PERMITTING AND ENFORCEMENT COMMITTEE

DEVELOPMENT OF SOLID WASTE MANAGEMENT FACILITIES ON INDIAN
COUNTRY

Permitting and Enforcement Committee
April 21, 1993

ITEM: Discussion of CIWMB Participation in Cal/EPA Integrated Inspections

Lower Hemisphere Equal Area Stereographic Projection
of Poles to Joint Planes Observed at Ground Surface

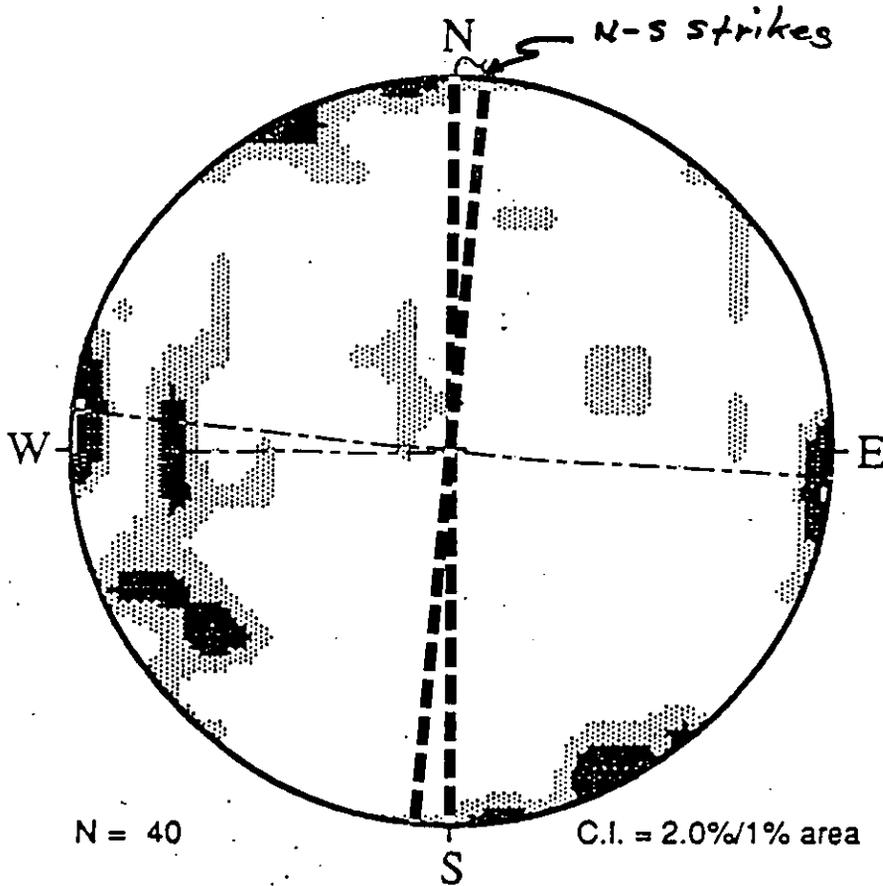
Figure 7-1 is a lower hemisphere equal area stereographic projection of poles to joint planes observed at ground surface. There are two sets of north-south trending planes clearly identified on the plots. One set is nearly vertical and is shown by the dark areas on the east and west perimeters of the plot. The other set is striking north-south but dips around 60 to 70 degrees to the east. As I said, these sets are not discussed and, therefore, Dames and Moore's knowledge of the geologic structure is flawed. In addition, what they do discuss in the text points out additional flawed analyses and knowledge. They say, and I quote, "Dips were generally nearly vertical except for the northeast-southwest direction." (page 74). They are obviously identifying the plots of the poles as directional strikes of the planes. Please see the attached Figure 7-1 modified to identify the north-south strikes shown on the plot.

Lower Hemisphere, Equal Area Stereographic Projection
of Poles to Joint Planes Observed During Regional Mapping

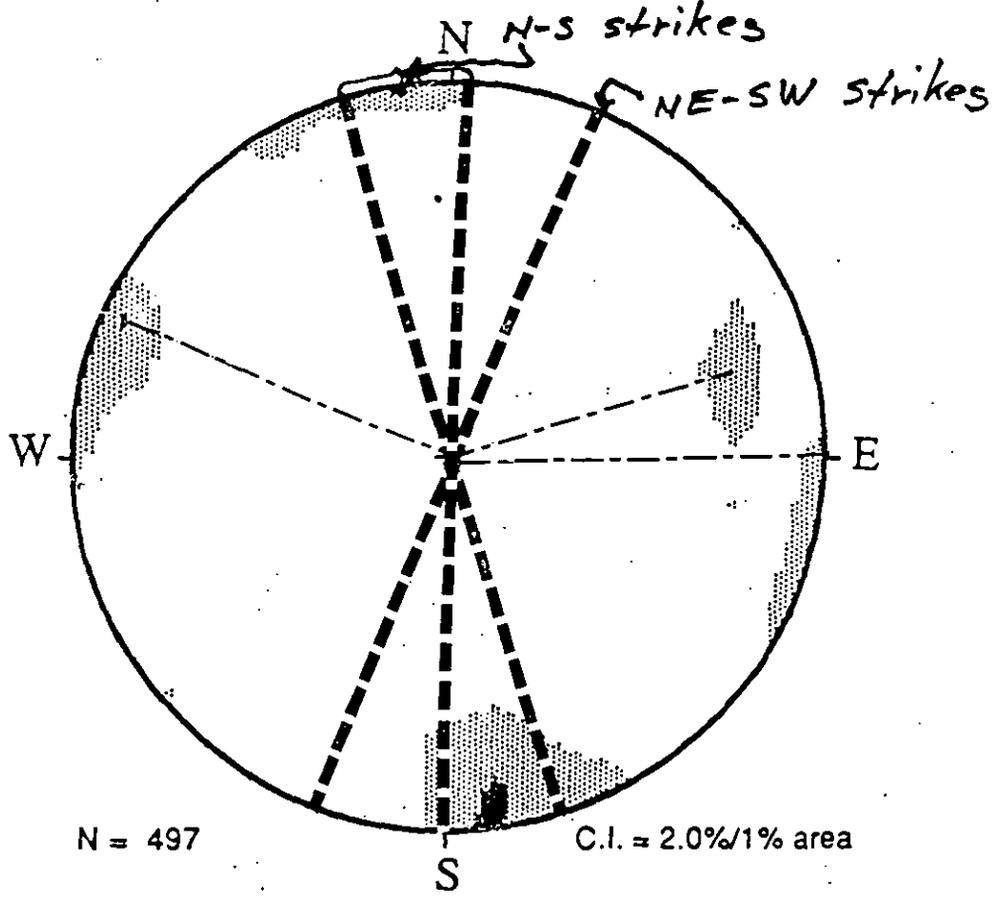
This flaw is expanded as they move to Figure 7-2 when they state that "Northwest-southeast and east-west trends dominate, but with marginally different strikes." (page 74). However, Figure 7-2 shows that north-south and northeast-southwest strikes dominate. Please see the attached annotated figure 7-2. These Dames and Moore statements are not misprints. Dames and Moore is associating the plot of the poles to a directional indication of the strike. These analyses and interpretations are wrong, their knowledge of the fracture system is flawed, and the design which is based on this inaccurate understanding is flawed. I would reject the application on this fact alone.

Lower Hemisphere, Equal Area Stereographic Projection
of Poles to Fractures Observed in the Subsurface

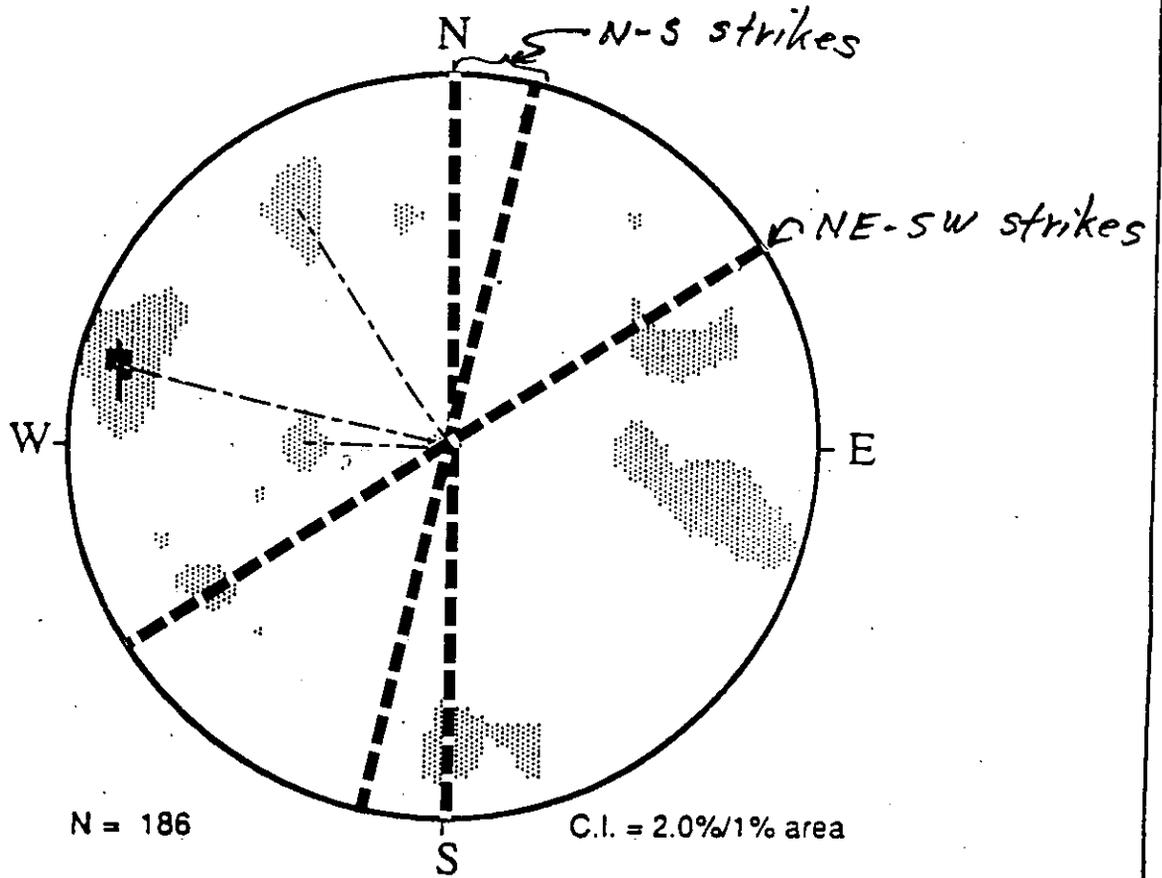
2. Figure 7-4 presents a lot of information concerning subsurface fracture systems. This subsurface data is not being used to help identify the structural zones which are the basis for the design. It is obvious that northeast-southwest trending discontinuities dominate in the subsurface, as reflected in the geophysical surveys. Please see the attached modified Figure 7-4. However, the structure zones identified in Figure 7-5 show northwest-southeast and east-west trends. They should be looking for north-south trends also. Where are the structural zones which are associated with the northeast-southwest and north-south trending discontinuities? They have a distorted view of the fracture systems and their relationship to the project.

**LOCATION OF
MAIN STRUCTURAL ZONES**

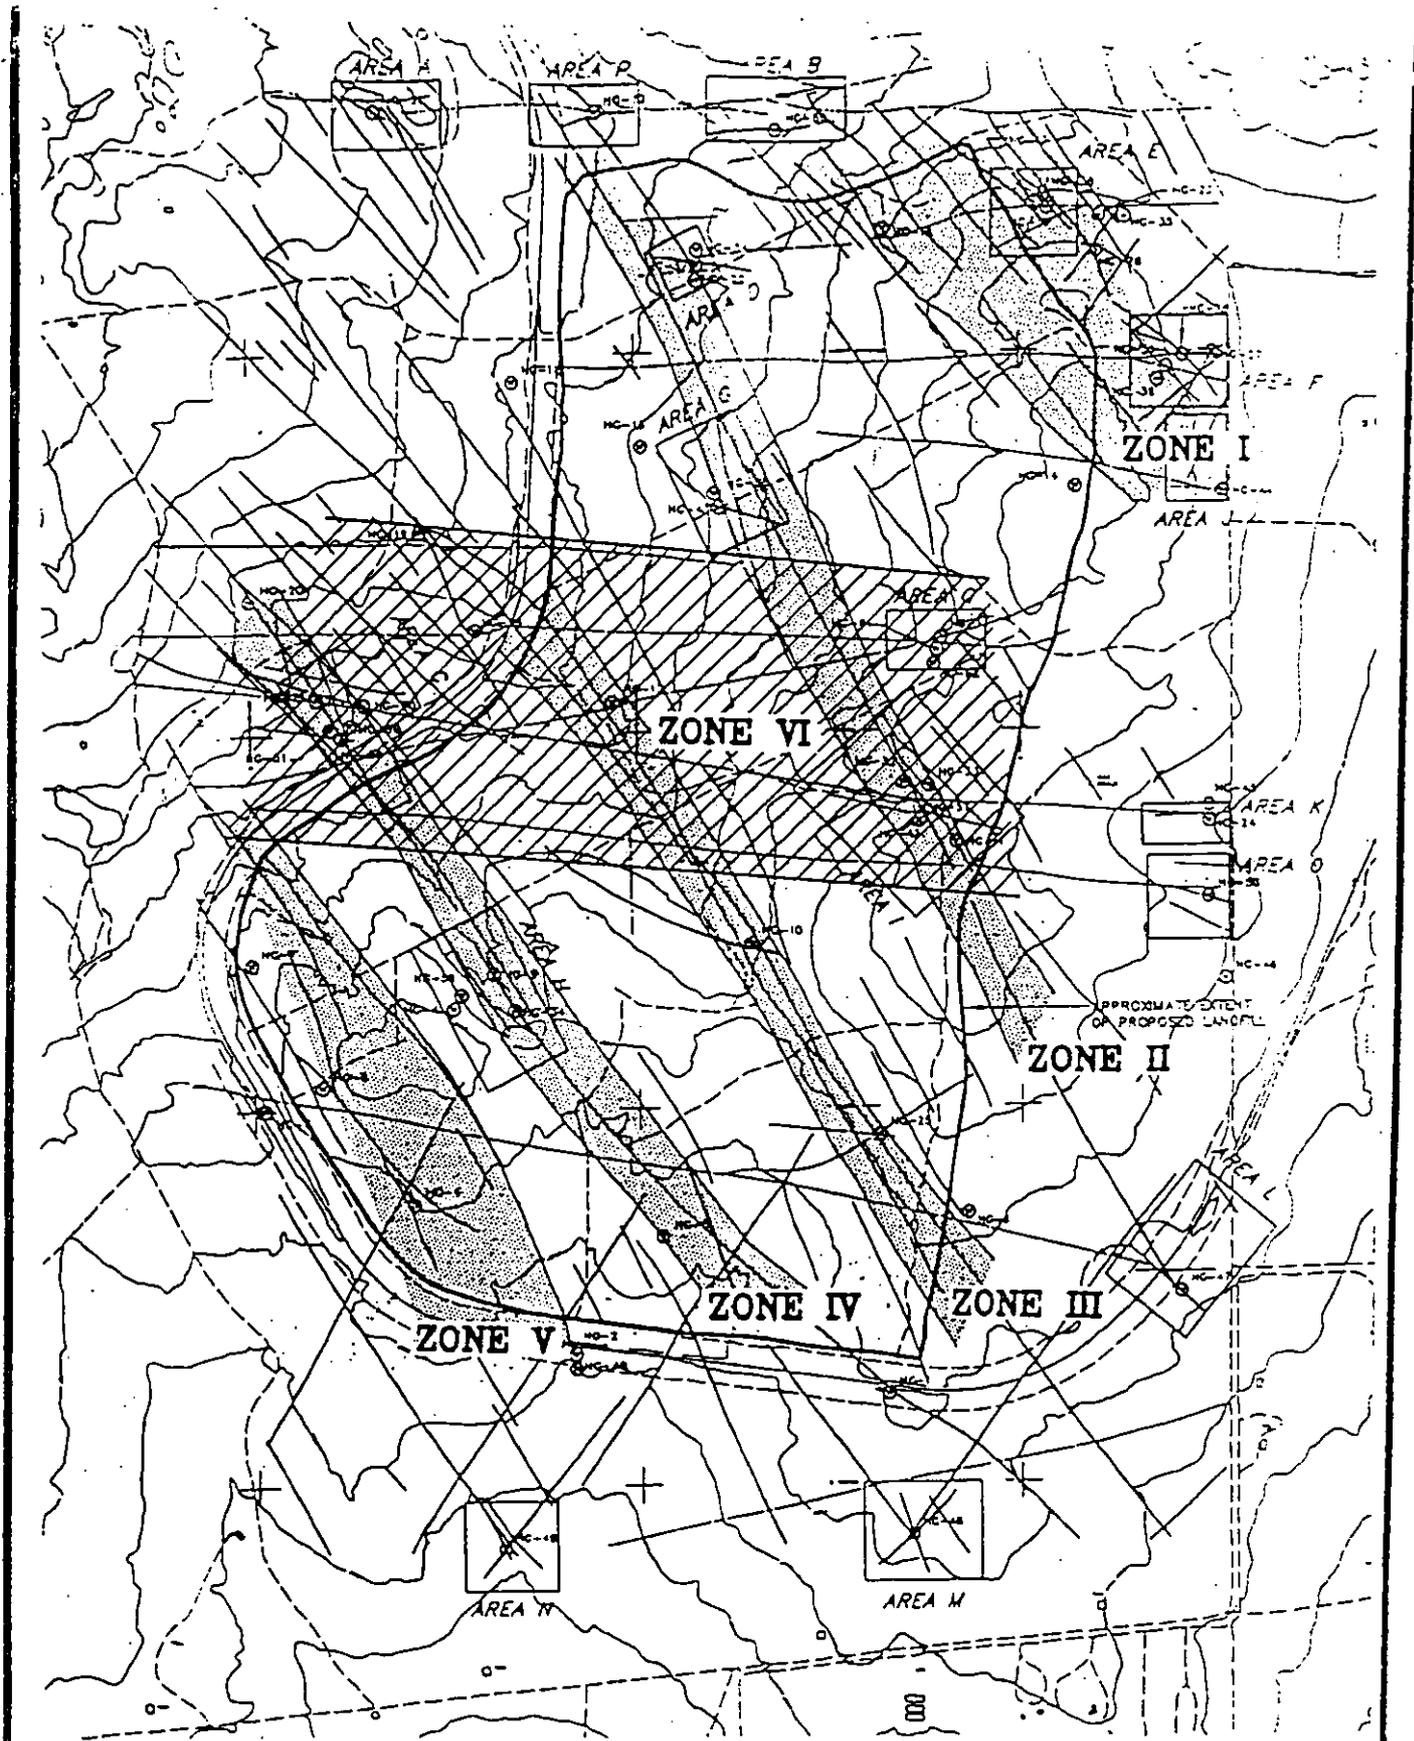
Their understanding of this detailed fracture system is flawed; therefore, their interpretation of the geophysical survey is flawed. Their assignment of structural zones I-IV shown on Figure 7-5 is flawed. These zones may exist but their orientation and location are very likely in error, and they say: "The structural zones will provide a basis for design of the monitoring program in unweathered tonalite." (page 78) Please see

attached Figure 7-5.
